Comparison Report

13-210-E008 3KC00005210

13-210-E009 3KC00005220

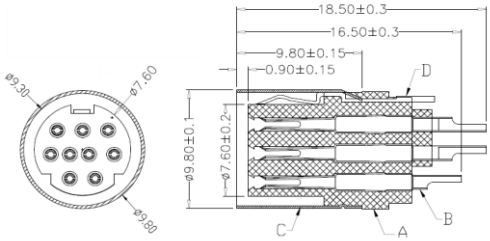
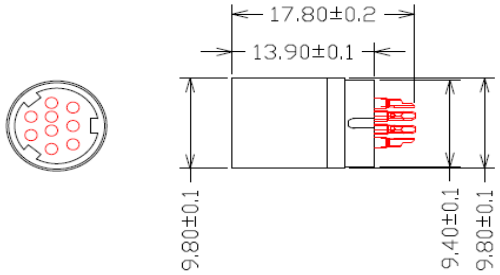
Item	昌駿 CJ-MD9A-F01	贛泰 GT-MD-030
Pictures

W	Ø9.80±0.1mm	Ø9.80±0.1mm

This component change has been evaluated by DIVA; the initial successor evaluation showed the new successor is compatible with former model. None of the other components and program will be needed to recalibrate or implement. The ECN will be provided if you approve.

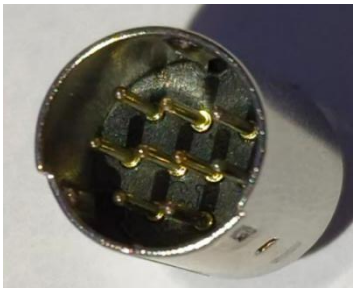
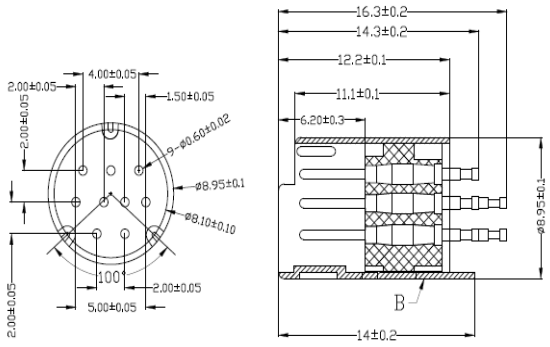
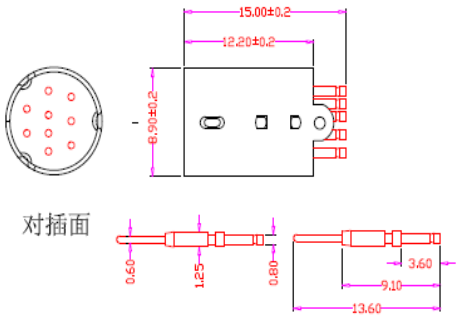
Item	昌駿 CJ-MD9-M13	贛泰 GT-MD-029
Pictures

W	Ø8.95±0.1mm	Ø8.9±0.2mm
